Hydrograph by Return Period

Project Name: Native Sun Construction, Proposed Drainage Plan, CD Civil Design LLC

Project Name: Native Sun Construction, Existing Drainage Plan, CD Civil Design

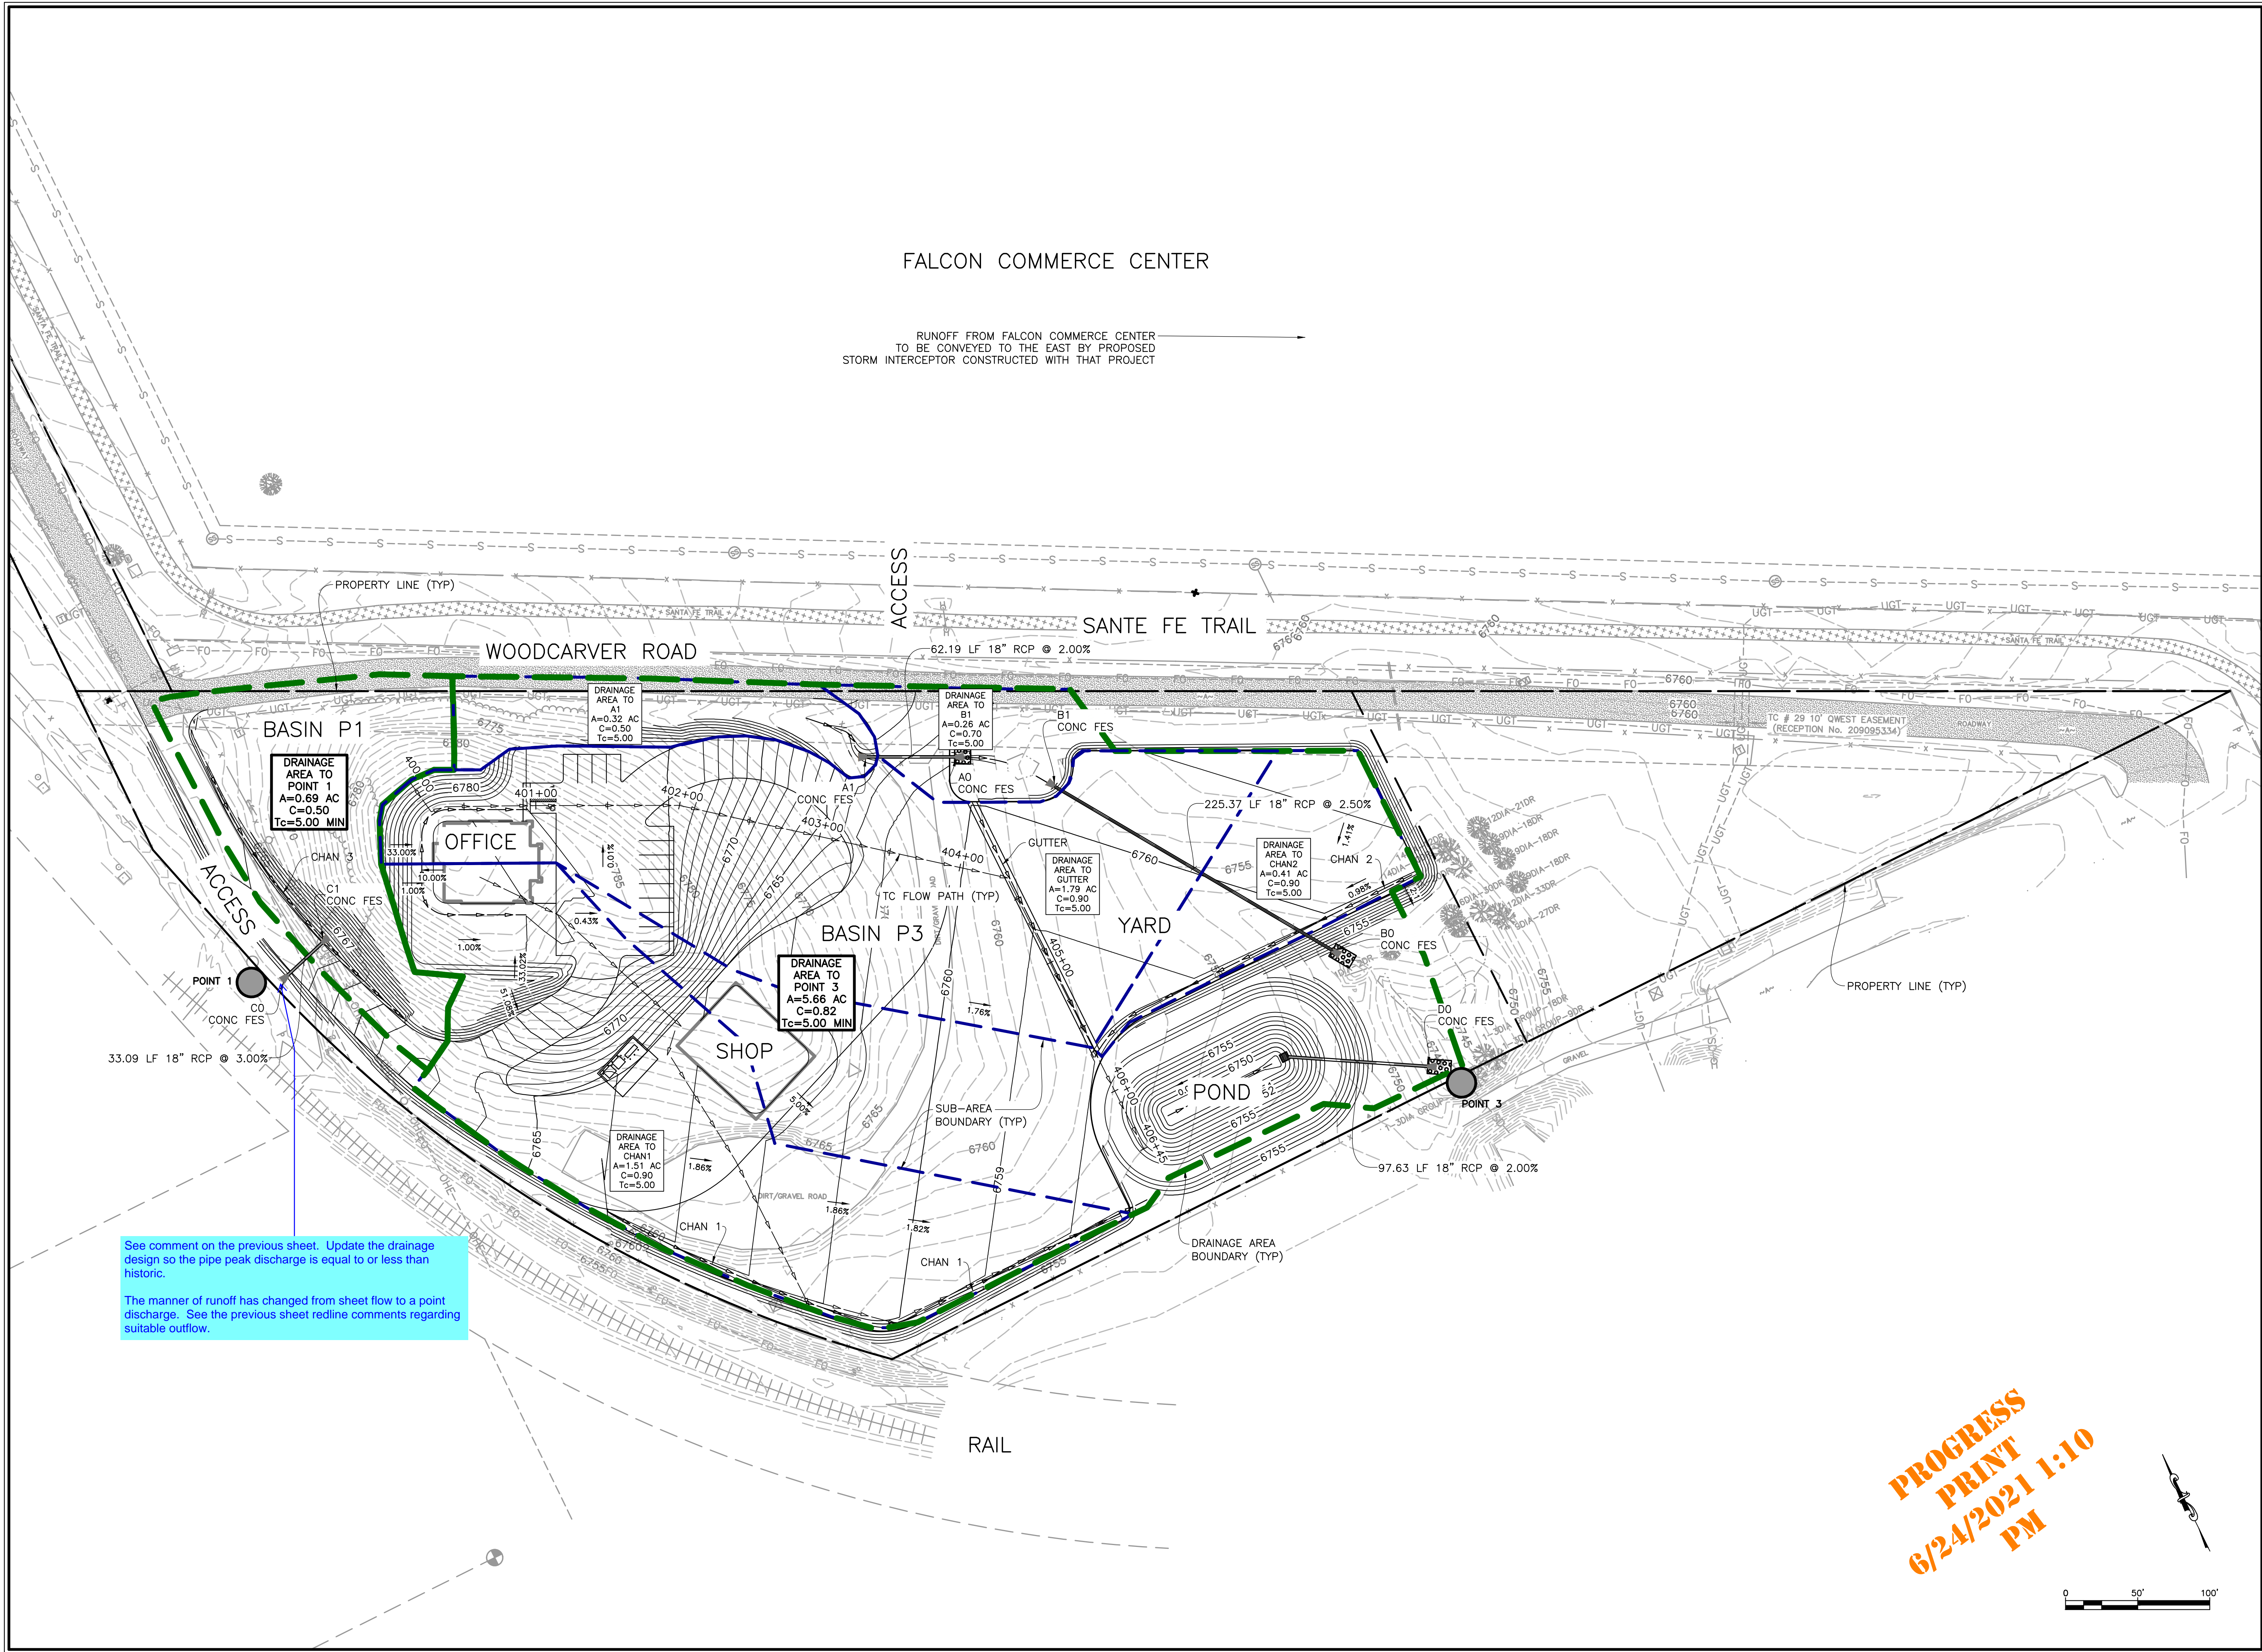
Check Calculations for Basin P1 and Basin E1. This design point discharges into Unincorporated El Paso County and the proposed condition peak flow rate is greater than existing. Per County criteria the flow exiting the property must be equal to or less than historic.

Additionally, provide analysis from the pipe to the suitable outfall. The proposed condition has change the characteristics of the runoff from sheet flow to concentrated flow. Additional offsite improvements may be required if the flow path between the pipe and what is considered the suitable outfall is shown to not be hydraulically adequate. See the County's Engineering Criteria Manual Chapter 3 Section 3.2.4 for the definition of suitable outfall.

You can contact the El Paso County review engineer (Gilbert LaForce, gilbertlaforce@elpasoco.com, 719-331-7134) for clarification. Provide the following reference file no. OAR21-102.
